From: [Nik Argirov](#)
To: stevepellerin@lowerchurchillproject.ca
Cc: ["Krupski, Joseph \(NRCan/RNCan\)"](#)
Subject: Nalcor - July '16 IE Site Visit Report
Date: Tuesday, September 20, 2016 7:05:17 AM
Attachments: [.png](#)
[2016-09-09 Nalcor -July 11 to 15 2016 IE Site Visit.docx](#)

MEETINGS IN ST. JOHN'S AND VISITS TO LOWER CHURCHILL PROJECT SITES, JULY 11 TO 15, 2016

Prepared for: Natural Resources Canada and Nalcor Energy
 IE Point of Contact: Nik Argirov
 Date: September 20, 2016

Figure 6.1: Upstream cofferdam cross section. Provisional cutoff curtain outlined in red.

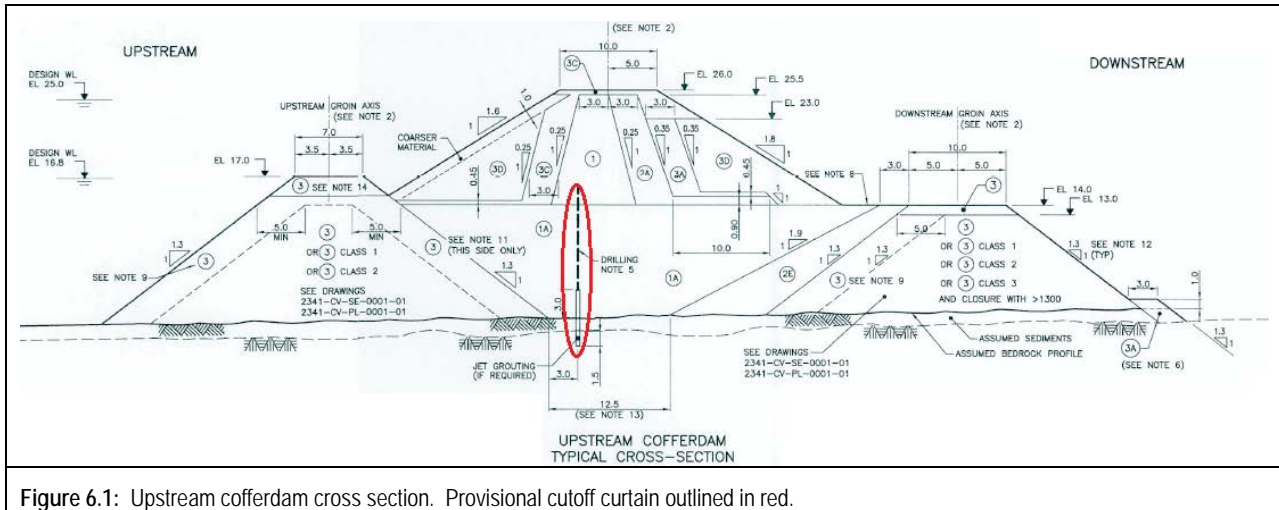
The Muskrat Falls Upstream cofferdam is a 450 m long embankment structure located upstream of the planned main RCC dam. It will be approximately 24 m high and consists of lower dumped starter dam topped off by a compacted fill embankment dam, as shown on Figure 6.1 below. The starter dam consists of a 5 m to 12 m high structure, constructed from the riverbed up to el 14 m that consists of two rock fill groins with a dumped till impervious zone placed in between them. Dumped transition rock fill zones are placed on the groin slopes upstream and downstream of the impervious zone and a granular filter zone will be sandwiched between the downstream impervious and transition zones. A 12 m high conventional centre core embankment dam will be constructed on top of the starter dam up to el 26 m. The overall design of the cofferdam is conventional and in line with accepted practice. The IE believes, however, that there is some risk of relatively high foundation leakage in a few areas, as discussed in the following paragraphs:

The rockfill groins of starter dam will be placed on the natural riverbed. The impervious fill zone will be about 12.5 m wide at the base and will be placed on the cleaned riverbed between the groins. Much of the impervious foundation will not likely be fully dewatered because of copious water flow. Due to likely water inflows hand/air pressure cleaning will not be possible for much of the foundation and these areas will be machine cleaned with backhoes. Most of the riverbed bedrock foundation will have been scoured clean by river flows and will provide a good seal at the base of the impervious fill. In submerged areas that have not been scoured by the river, machine cleaning will remove most of the debris and overburden from the bedrock surface. It is possible, however, that the machine cleaning will miss some debris materials or zones of disturbed, broken rock.

The IE submits that there is a risk of serious leakage in submerged foundation areas where debris, boulders, broke/disturbed rock have not been completely removed by machine cleaning. Significant water flows can generate extra costs in terms of schedule delays, beneath the impervious zone. It appears that the designers have considered this risk by including the contingency jet grouting in the design. Details of the contingency jet grouting program are shown on Drawing MFA-SN-CD-2340-CV-SE-0002-01 Rev C2. The grout holes would be drilled through the core into the permeable material at its base. The IE notes that jet grouting will be very effective in sandy or granular overburden, but will have limited success in open-work boulders or broken rock.

The July 3, 2016 Barnard Pennecon North & South Dams Work Plan document is in line with current practice for cofferdam construction. This document describes the planned machine cleanup and final bathymetric surveys for the foundation area between the groins. This plan is acceptable. However, no details of the contingency grouting are presented or discussed. It is not clear if the contractor has made any provisions to do this work if it proves to be needed. Jet grouting requires specialized equipment and long delays can be incurred if this has not been procured in advance.

- Barnard Pennecon should supplement its work plan with a contingency plan for dealing with unexpectedly high water flows through the cofferdam foundation. This must include plans for pumping leakage water downstream of the cofferdam and construction of a cut-off through the base of the core if needed.
- The cut-off can be the jet grouting scheme proposed by the designers on Drawing MFA-SN-CD-2340-CV-SE-0002-01 Rev C2 (see Figure 6.1 above). Alternatively, a local slurry cut-off wall could be constructed using equipment already present at the site. It is noted that a slurry cut-off is better suited for dealing with open-work boulders than jet grouting.
- The contractor should demonstrate that equipment can be available on a timely basis to deal with unexpected foundation water inflows so that the potential impact on schedules is minimized.
